Subject: Response to Request for Additional Information
Southeast County Landfill, Hillsborough County
Capacity Expansion Section 8
Certification of Construction Completion
Permit No. 35453-009-SC
Jones Edmunds Project No. 08449-020-01

Following our meeting on June 14, 2006 to discuss the Section 8 Certification of Construction Completion Report (Report), you had requested some additional information to be submitted to our office to assist you with completion your approval of the Report. The additional information that you requested is listed below.

Plotted: 7/21/06 2:39pm jvance

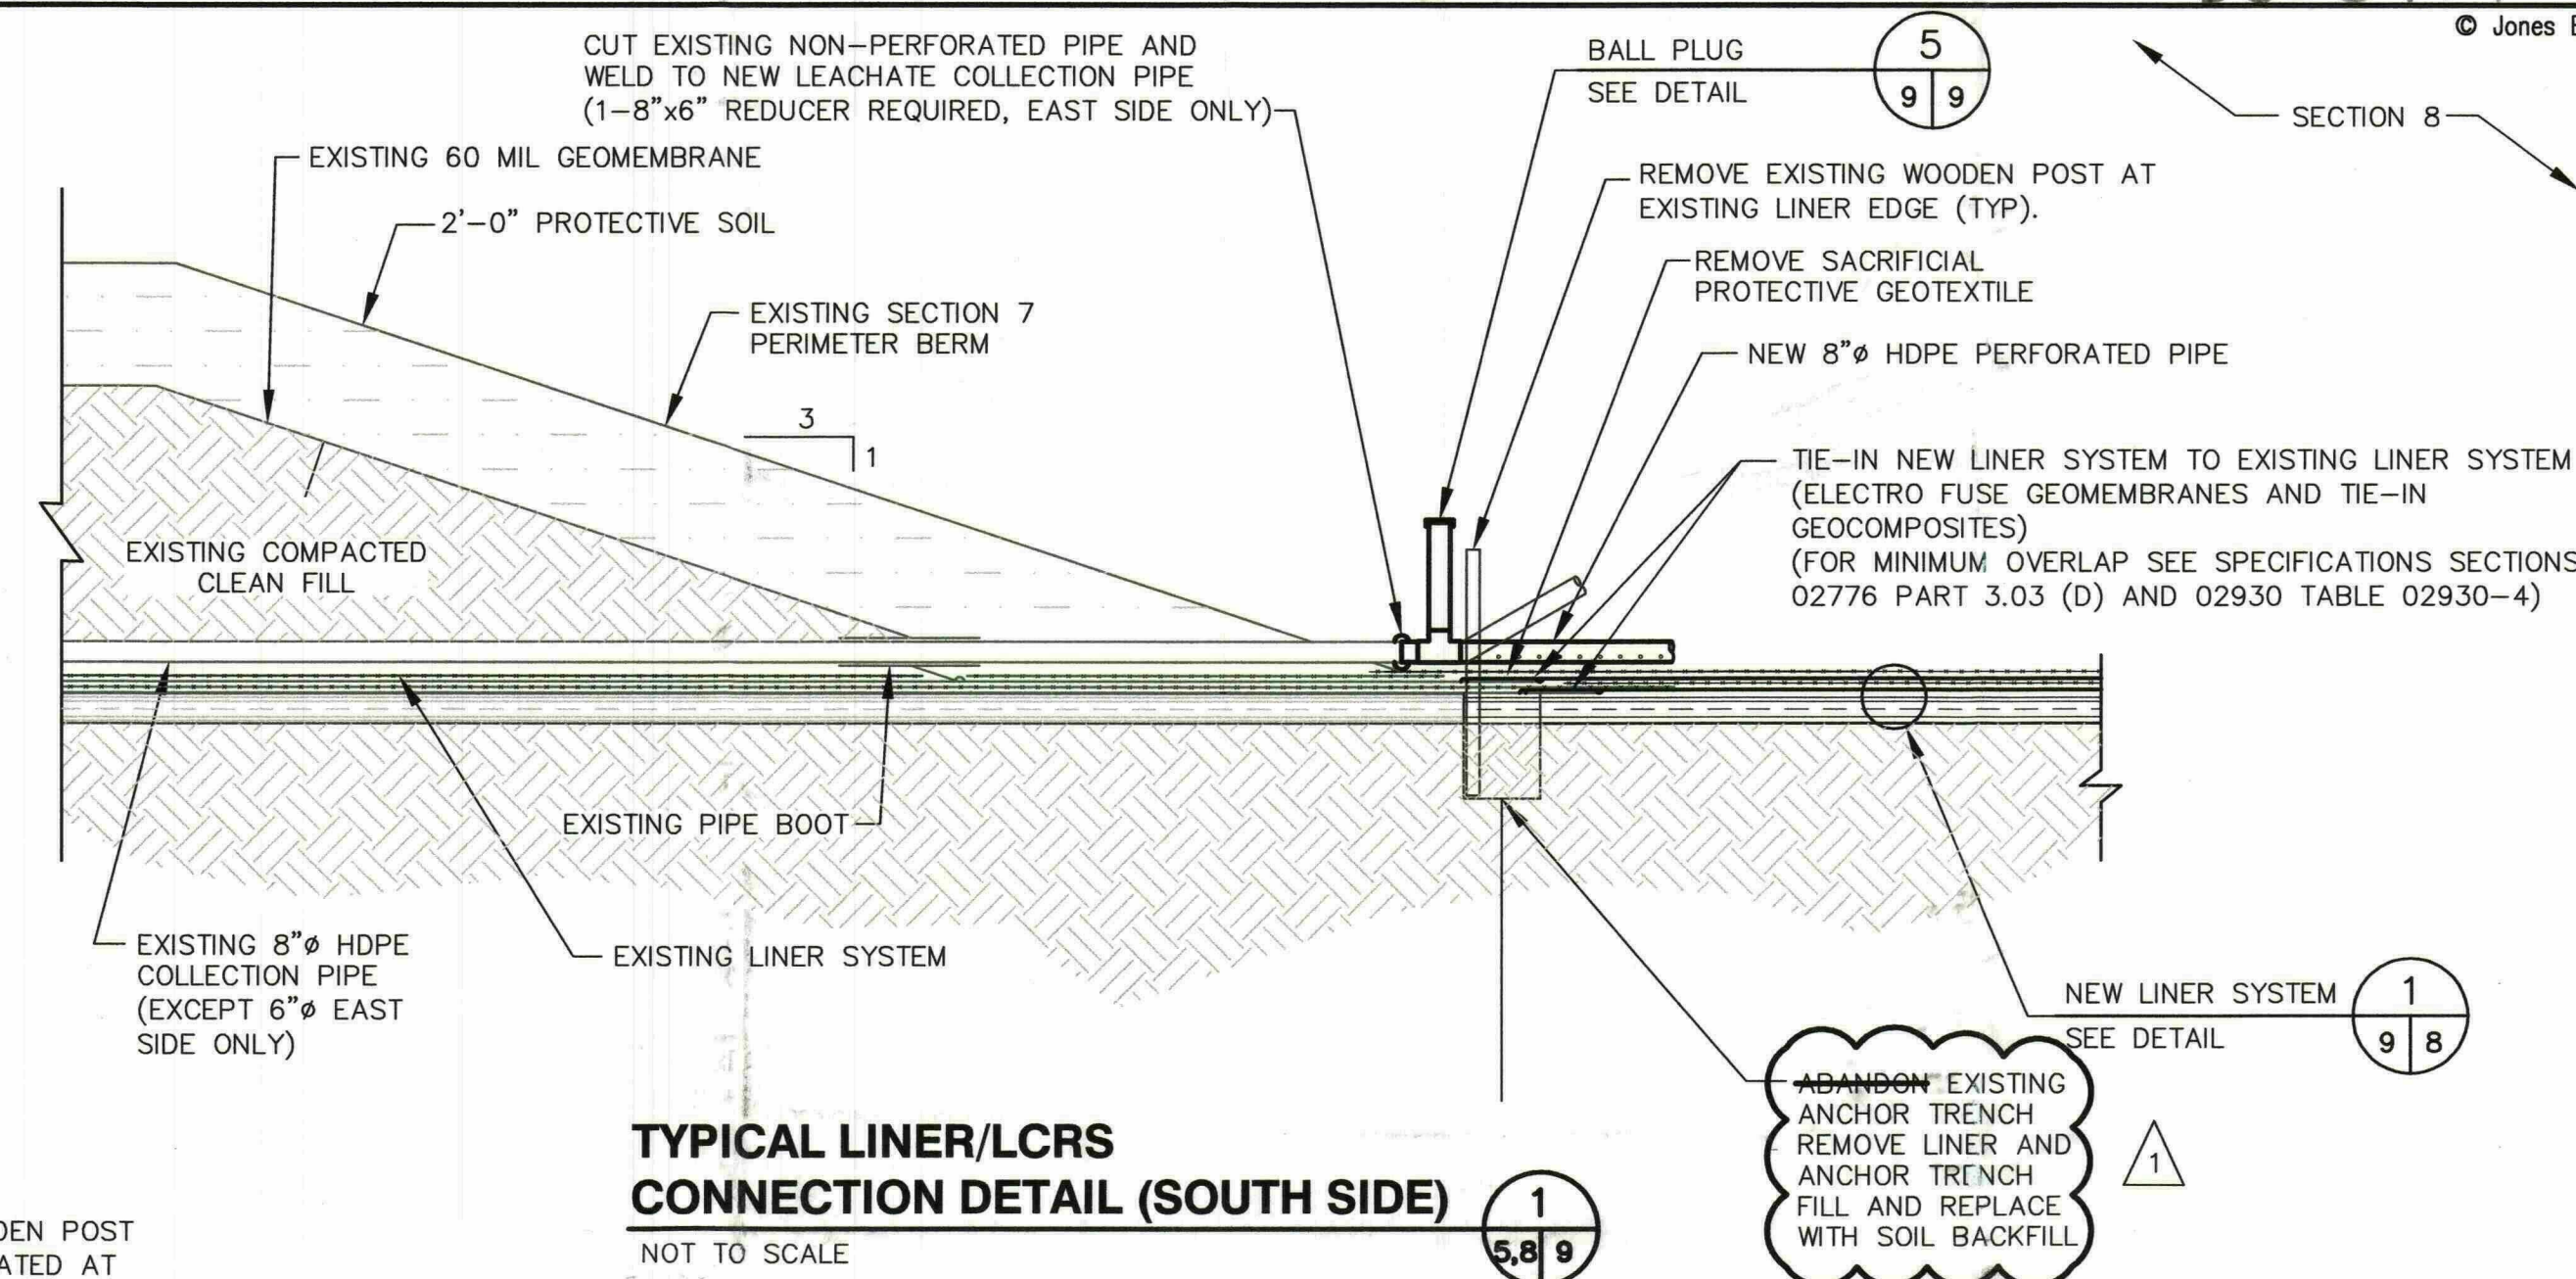
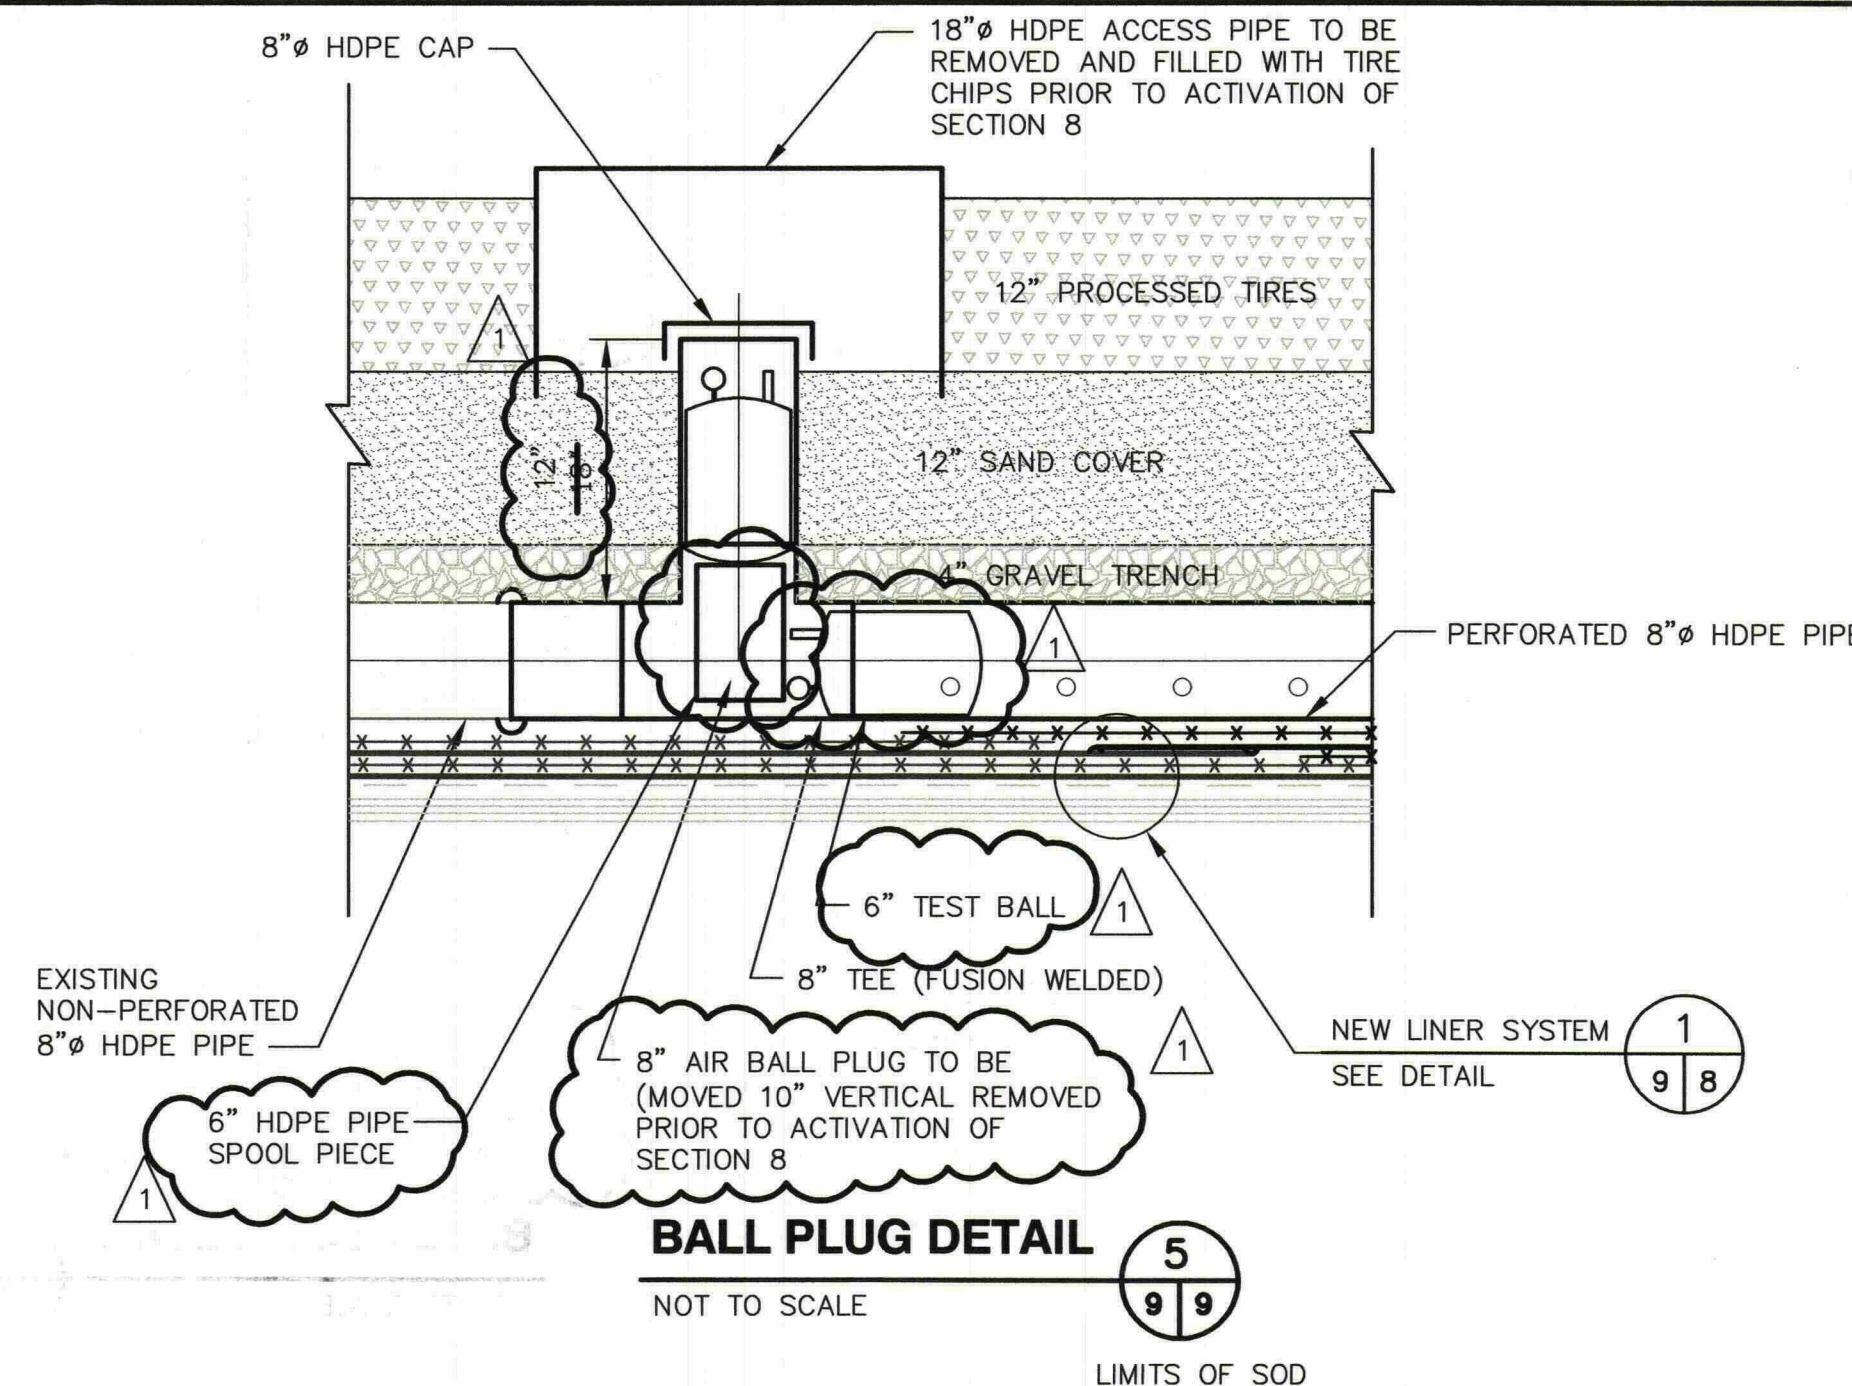
Comment 19) Please resubmit Drawing No. 9, Detail 6 with drainage information from the Pickett Survey .

Response 19: Provided in Attachment 13 is a revised Drawing No. 9.
